Access Compliance Report

Public Rights-of-Way

(Curb Ramps)

Intersection ID: 11913	Main Street: MIDLAND_AV	Cross Street: BEAUX_ST	Location: W
ADA ID: F88D3148C998	Ramp Type: Perp	Initial Pass/Fail: Fail	Overall Compliance: No
Severity Score: 10			
Codes/Mitigation Info/Possible Solution		Field Measurements/Component Compliance

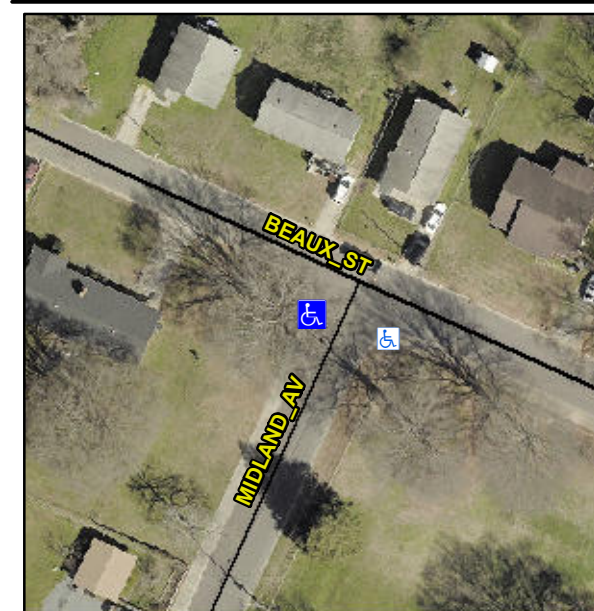
Not Found, R304.5.1, R304.5.3

Compliance	Description	Data	Compliance	Description	Data
N/A	Ramp Length (in)	72.0	Yes	Ramp Slope (%)	5.1
No	Ramp Width (in)	43.0	No	Ramp XSlope (%)	3.0
N/A	Flare Type LT	N/A	N/A	Flare Type RT	N/A
N/A	Flare Slope LT (%)	N/A	N/A	Flare Slope RT (%)	N/A
N/A	Flare Traversable LT?	N/A	N/A	Flare Traversable RT?	N/A
N/A	Landing Length (in)	N/A	N/A	DWS Provided?	N/A
N/A	Landing Width (in)	N/A	N/A	DWS Contrast?	N/A
N/A	Landing Slope (%)	N/A	N/A	DWS Length (in)	N/A
N/A	Landing X Slope (%)	N/A	N/A	DWS Full Width?	N/A
N/A	Landing Curb? (Y/N)	N/A	N/A	DWS Offset (in)	N/A
N/A	Shared Landing?	N/A			
N/A	Gutter Ponding?	N/A	N/A	Gutter Slope (%)	N/A
N/A	Gutter Lip Ht (in)	N/A	N/A	Gutter X Slope (%)	N/A
N/A	Painted X Walk1?	No	N/A	Painted X Walk2?	N/A
	X Walk 1 Direction	To SE		X Walk 2 Direction	N/A
N/A	X Walk 1 Width (in)	N/A	N/A	X Walk 2 Width (in)	N/A
	X Walk 1 Slope (%)	2.8		X Walk 2 Slope (%)	N/A
	X Walk 1 X Slope (%)	3.9		X Walk 2 X Slope (%)	N/A

Remove & Replace Entire Ramp.
